CITY OF NEWTON, MASSACHUSETTS

ADDENDUM #2

INVITATION FOR BID #12-32

LOWER FALLS COMMUNITY CENTER IMPROVEMENTS

1 ELEVATION- BACKBOARD MOUNT SCALE: 3/4"=1'-0"

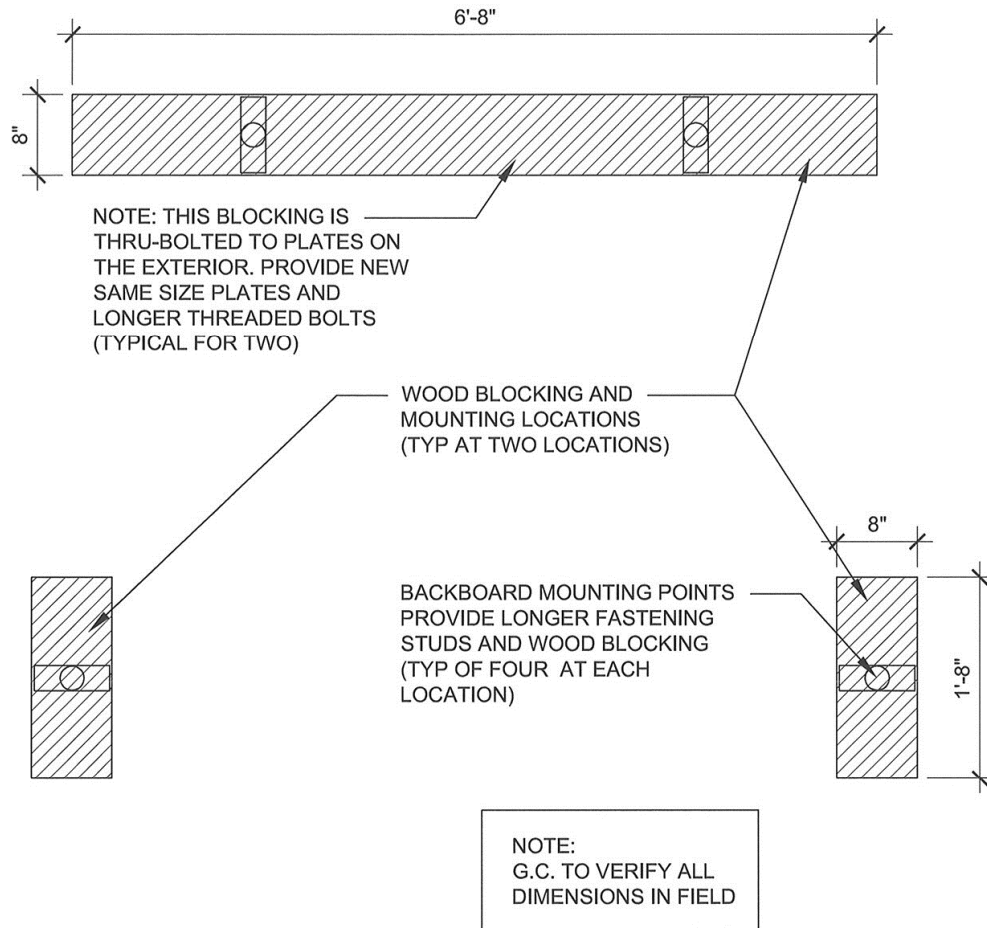
Q5. Gymnasium: Items are fixed on interior of perimeter walls where we insulate. How do we proceed? Remove and reinstall or other? Please Clarify.

Q14. At Gym nothing is shown for remove/reinstall of basketball backboards, emergency lighting, clock/intercoms?, or electric receptacles at wall pads. Is this work by others?

A5. Remove and store the two existing basketball back boards and supports and store in a safe place on site. Backboards are to be re-installed in same mounting locations and shall be the same distance from the foul lines when set on face of new wall. Refer to SK-01 for additional information. Remove the existing motion sensor at South-East corner and re-install in the same location when the new wall is completed. Remove existing emergency lights/cage at the East and West walls. Provide solid blocking for re-installation of light and cage at West wall only. Remove and discard clock and cage on the East wall. Remove emergency exit signs on the East and West ends of the north wall and the existing fire alarm pull and strobe are to be removed and rewired if required in order to install at new location. Only one illuminated exit sign is to be reinstalled above the new exit door. Refer to SK-02 for additional information. Terminate abandoned feeds from exit sign and clock at North-East corner of gymnasium and emergency light at East wall per City of Newton Wiring Department requirements. At two existing outlets on East & West walls, install workbox extenders in order for the existing outlets to be flush with the new finished wall surfaces.

A14. See attached SK.01 also Q.5, A5 in this addendum.

GENERAL NOTE: REMOVE EXISTING BASKETBALL BACKBOARDS AND EXISTING WOOD BLOCKING. REPLACE EXISTING THREADED RODS WITH NEW LONGER THREADED RODS SO THAT THE RODS WILL EXTEND PASS THE NEW BLOCKING (ROUGHLY 3") AND CAN BE FASTENED WITH REQUIRED NUT. INSTALL NEW RODS, RE-INSTALL EXISTING SOLID WOOD BLOCKING IN THEIR RESPECTIVE PREVIOUS LOCATIONS. PROVIDE TWO LAYERS OF 2X8 SOLID WOOD BLOCKING (SHOWN IN HATCH) ON TOP OF RE-INSTALLED BLOCKING. PAINT EXPOSED WOOD BLOCKING. PAINT TO MATCH WALL RE- INSTALL BACKBOARDS. ENSURE DISTANCE FROM BACKBOARD TO FOUL LINE IS SAME AS EXISTING

INTERIOR PARTIAL ELEVATION

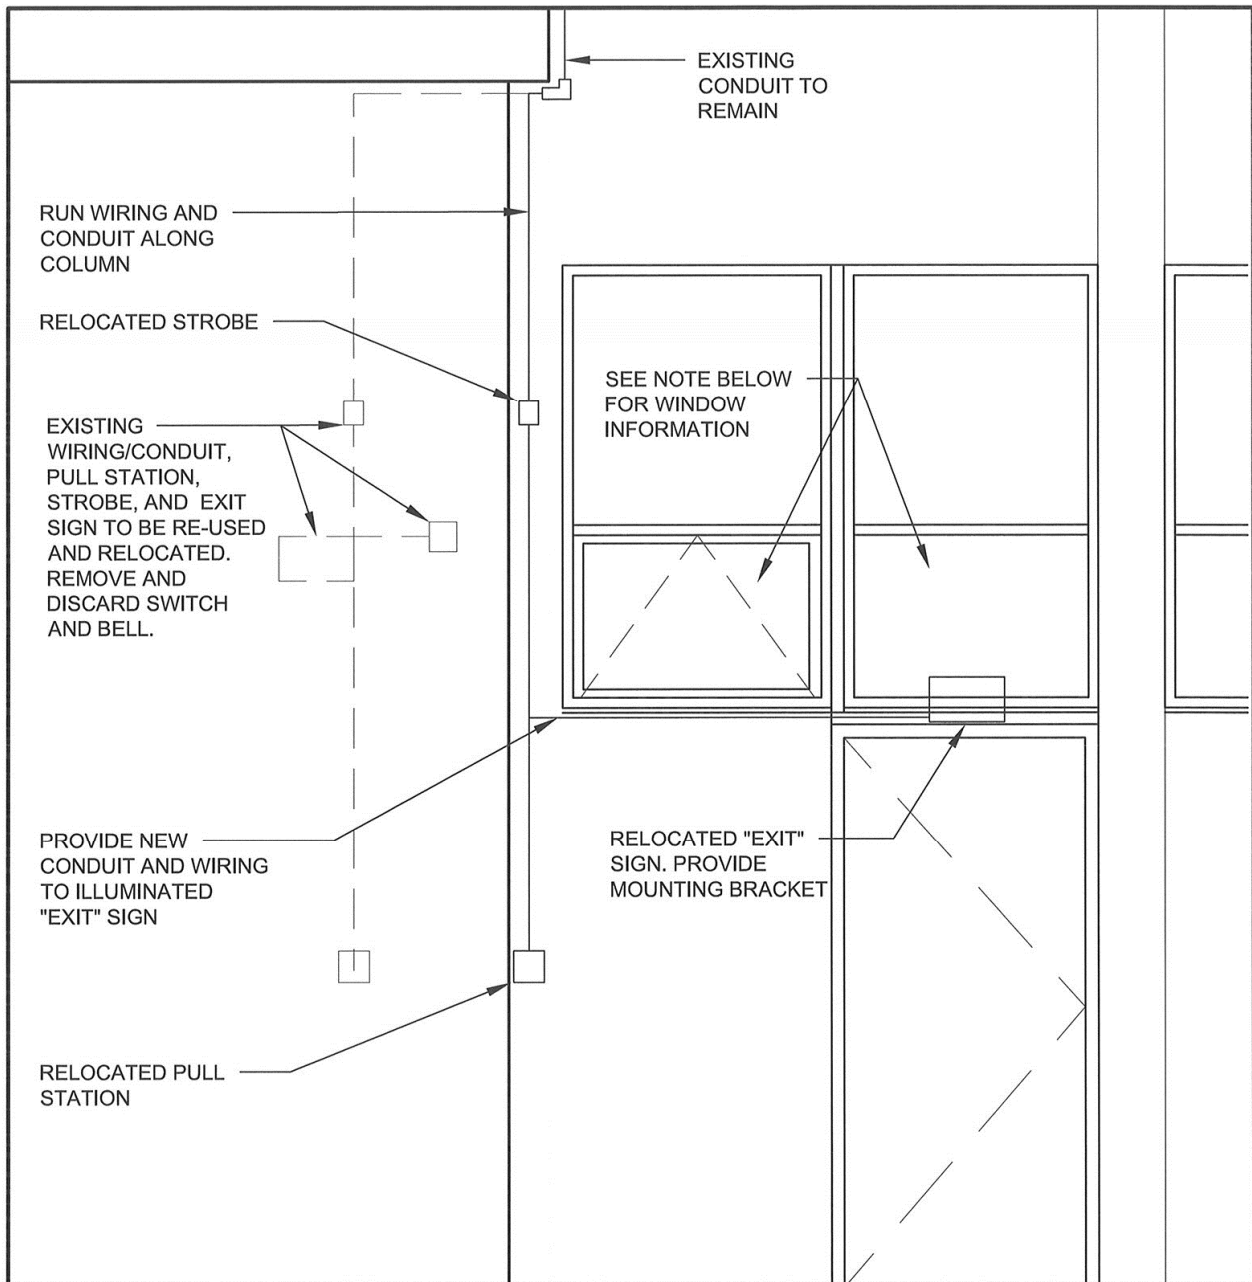
Q9. Please provide clarification as to who will be responsible for securing the fire alarm system during construction and what procedures need to be followed to do so.

A9. The Fire Department has indicated that it is required that fire protection of some form remain throughout construction. GC shall provide heat detectors in place of the existing smoke detectors where applicable within the space where work is being done. This process will require that GC hire a licensed electrician to coordinate with the fire department wire division, as they serve as the authorized service company for this property. The electrician shall submit a plan to maintain protection and secure a permit from the fire department. Once the construction is completed the original smoke detectors shall be reinstalled.

WINDOW NOTE: ELEVATION 3/A2 SHOWS A TYPE "E" WINDOW WITH AN OPERABLE WINDOW ABOVE THE DOOR. PLEASE NOTE THAT THE OPERABLE WINDOW HAS BEEN REVERSED IN ELEVATION SO THAT THERE IS NOW A FIXED WINDOW ABOVE THE NEW DOOR.
